A RESOLUTION AUTHORIZING THE MAYOR AND CITY CLERK TO APPROVE A CHANGE ORDER WITH MILESTONE CONSTRUCTION FOR WATER AND SEWER IMPROVEMENTS RELATED TO THE RAZORBACK GREENWAY REALIGNMENT PROJECT

Section 1. The Mayor and City Clerk are authorized to execute Change Order #1 to the Razorback Greenway Realignment Project for a change order of \$326,716.00 for water and sewer upgrades.

Subject: COR #001 Razorback Greenway Realignment

EMMA AVENUE WATER & SEWER UTILITY RELOCATIONS

W.1

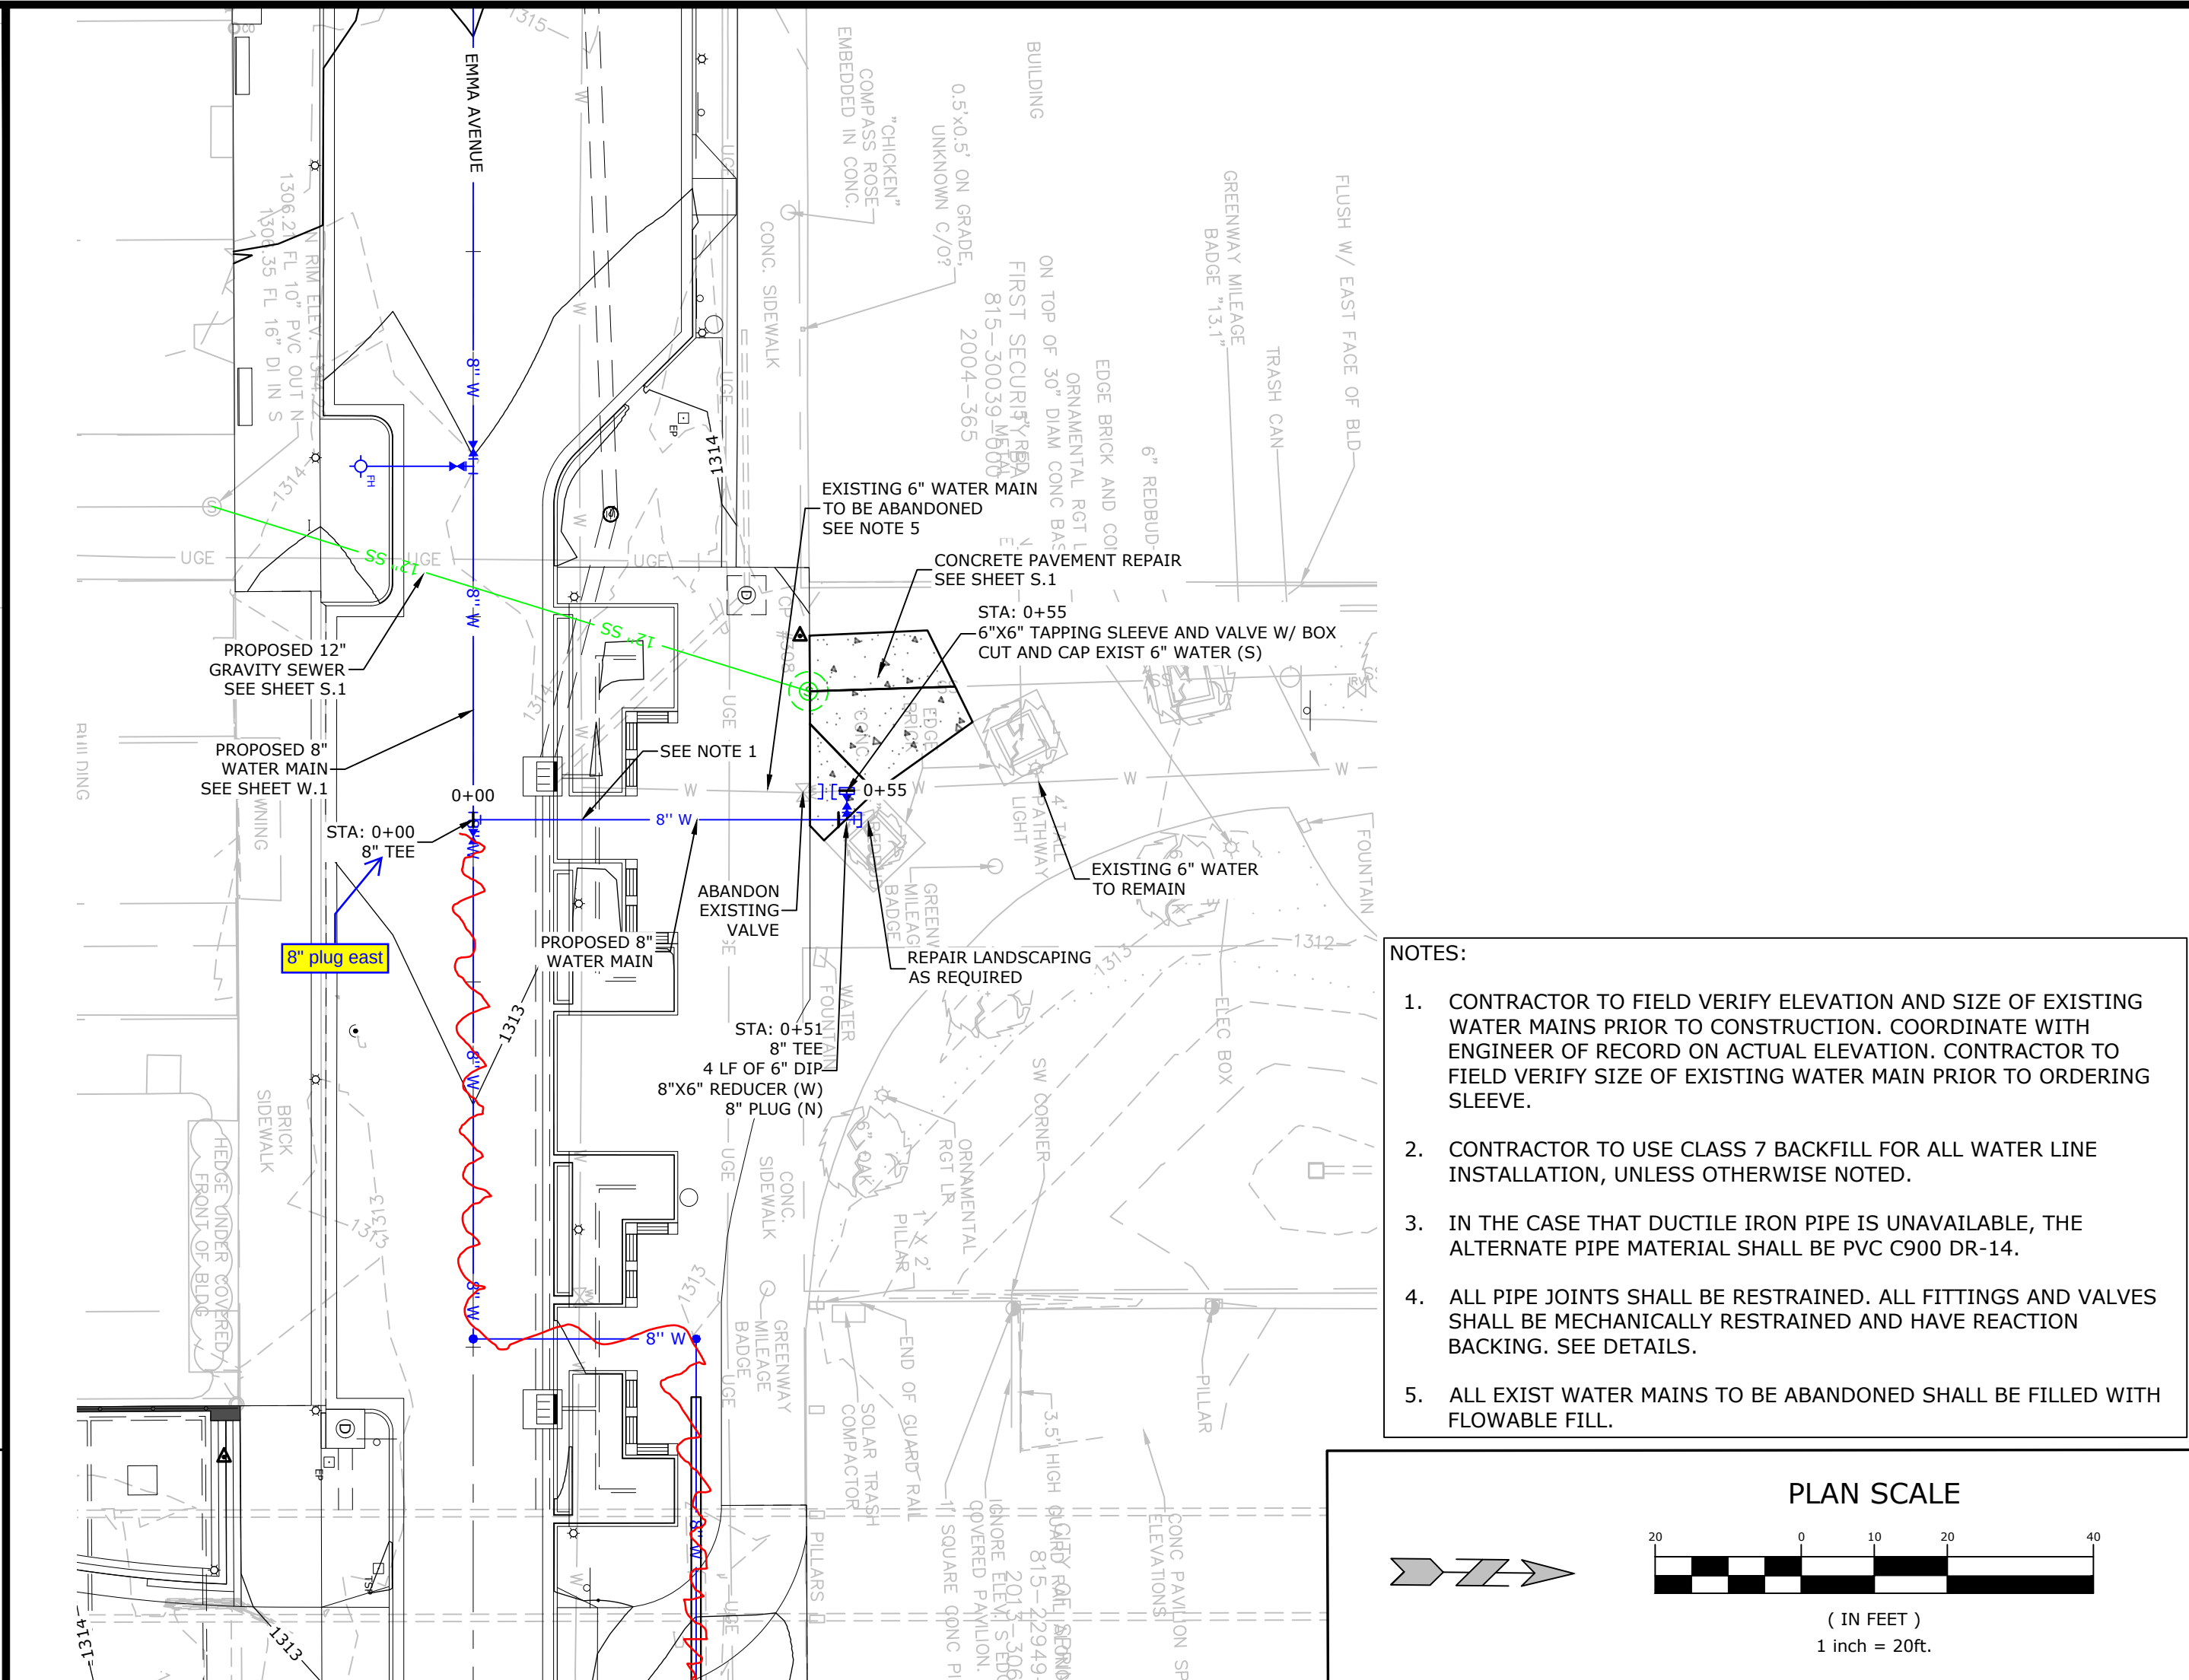
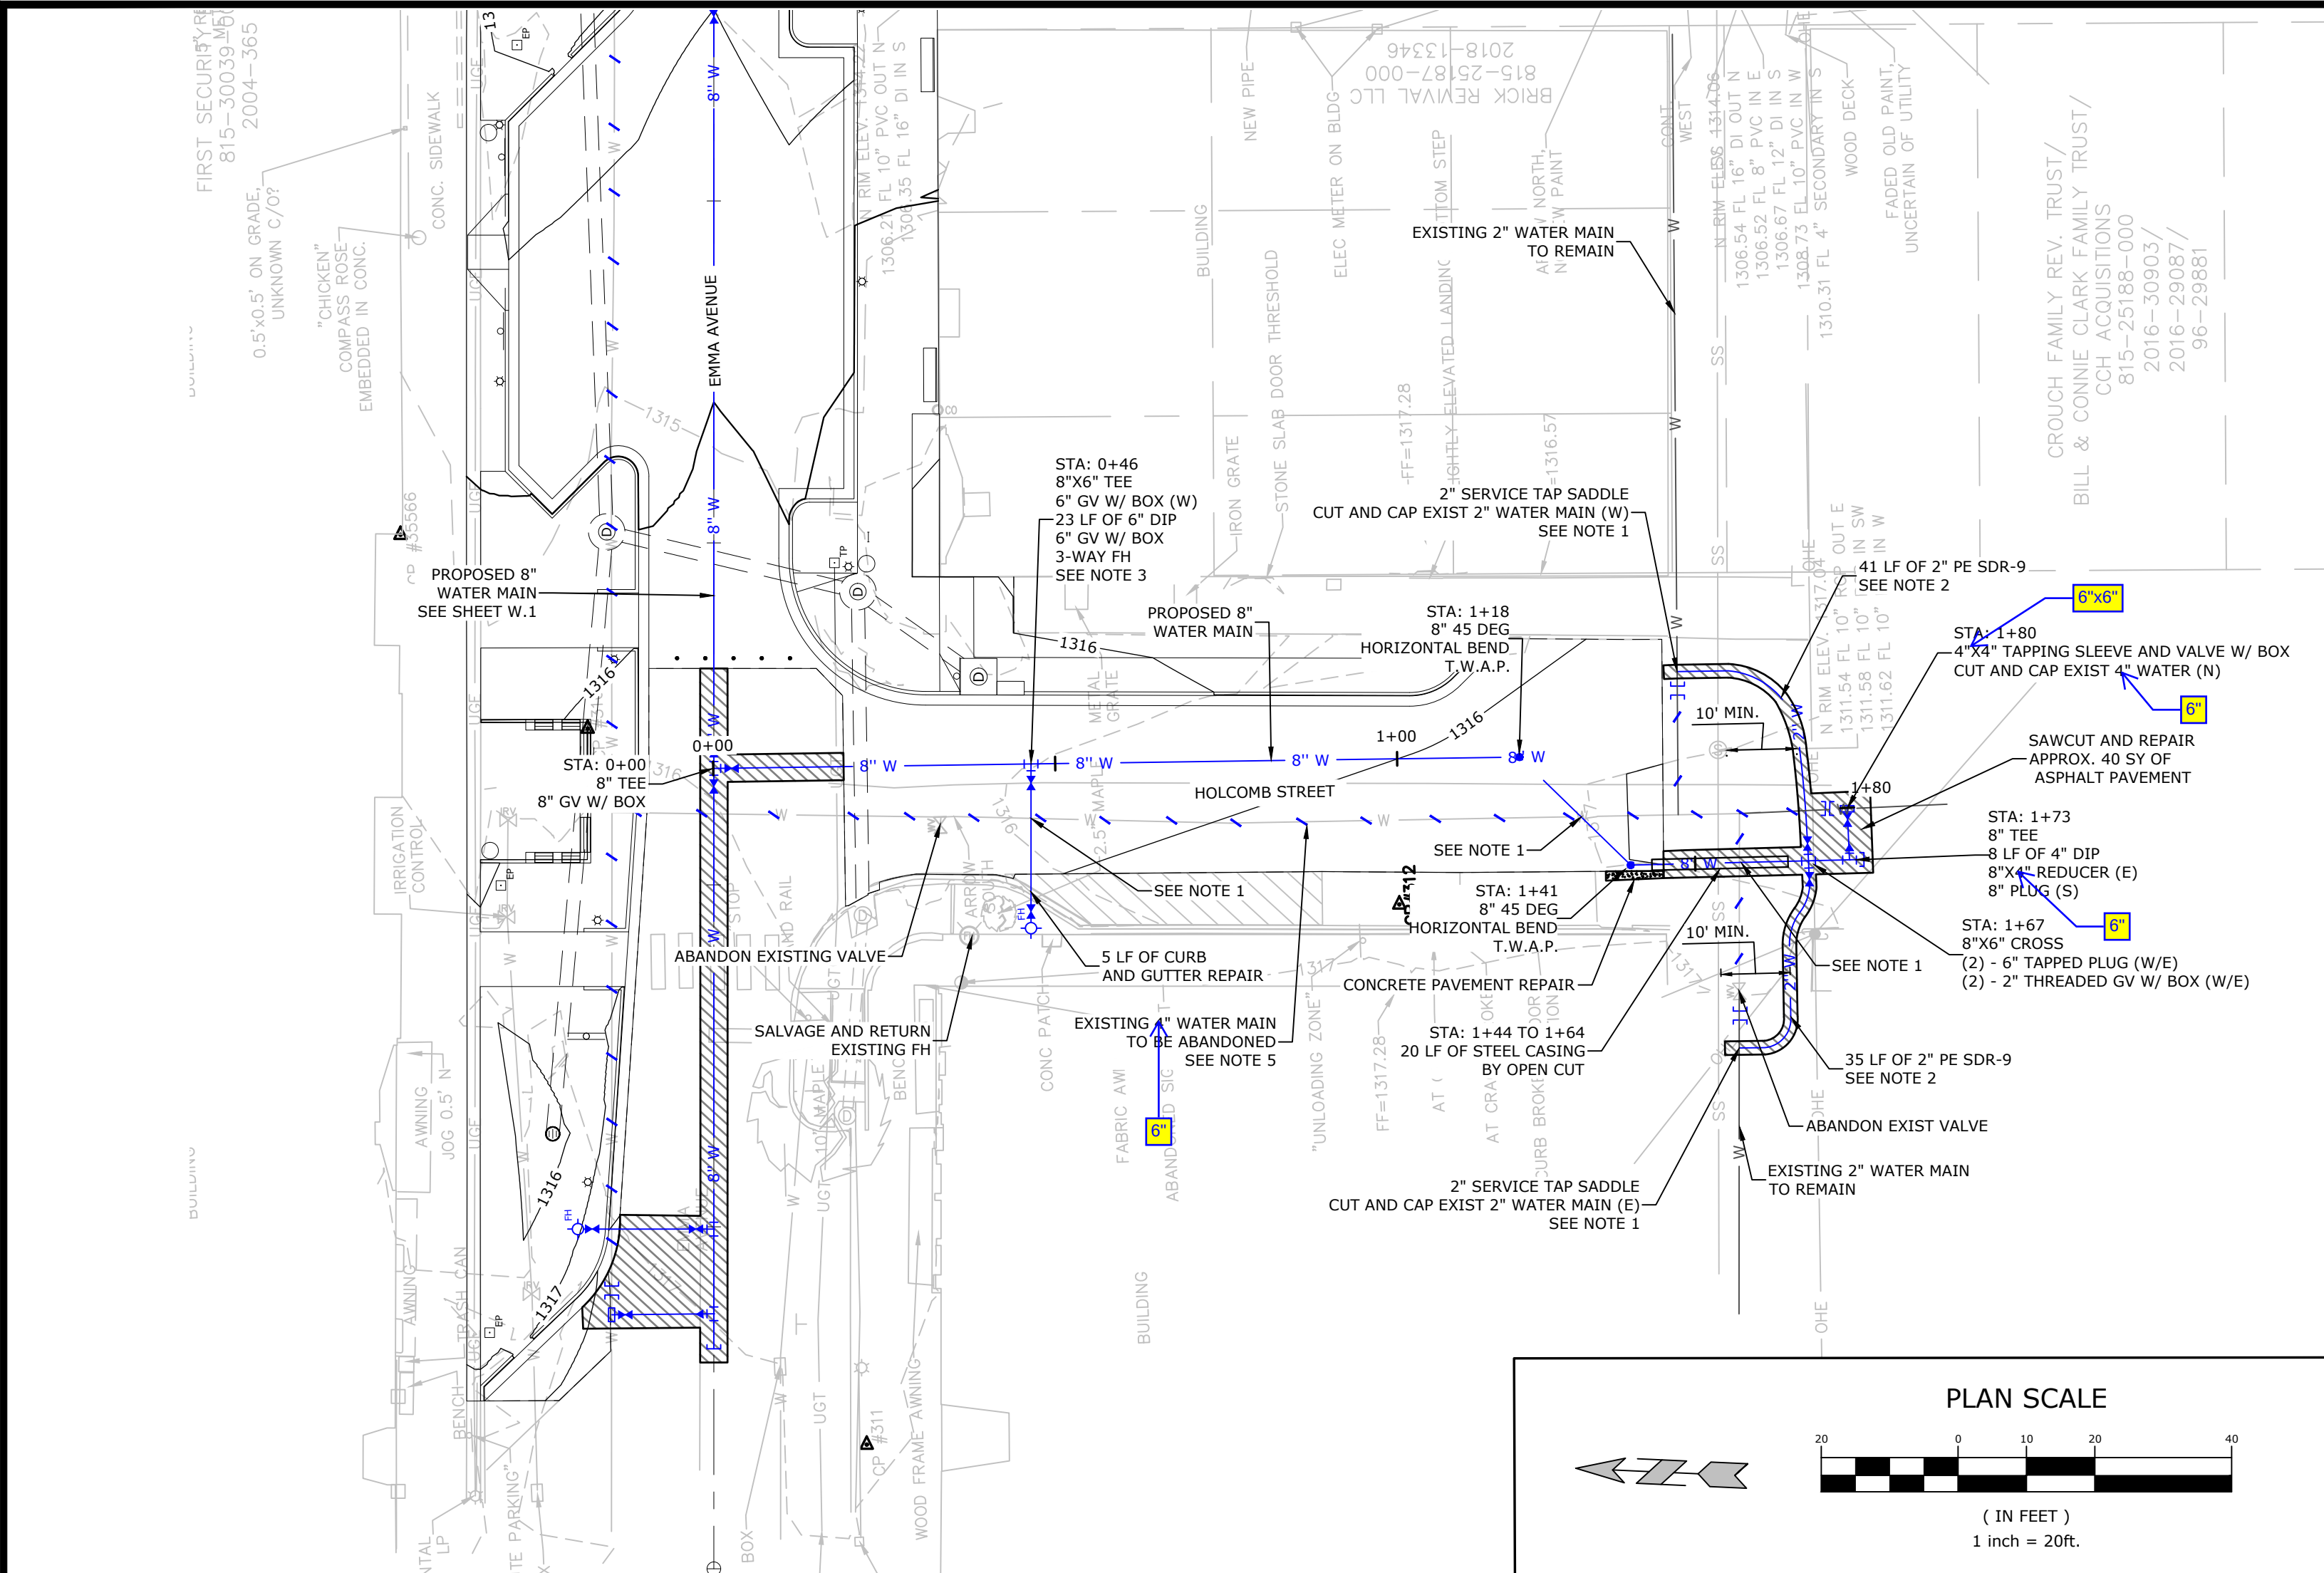
- a. Water – Provide and install water line as shown on the drawings on pages W1 & W2. Piping to be C900 DR-14. Price includes joint restraints, thrust blocks and steel encasement with guides. Includes valves, hydrants, and fittings as necessary to avoid existing utilities as shown.
- b. Includes removal and replacement of asphalt as shown on the drawings W1 & W2, including the removal of concrete in areas of asphalt removal as shown and down Holcomb Street as necessary to install new water line and cut and cap. Includes repair of asphalt as shown on W1 & W2 drawings.
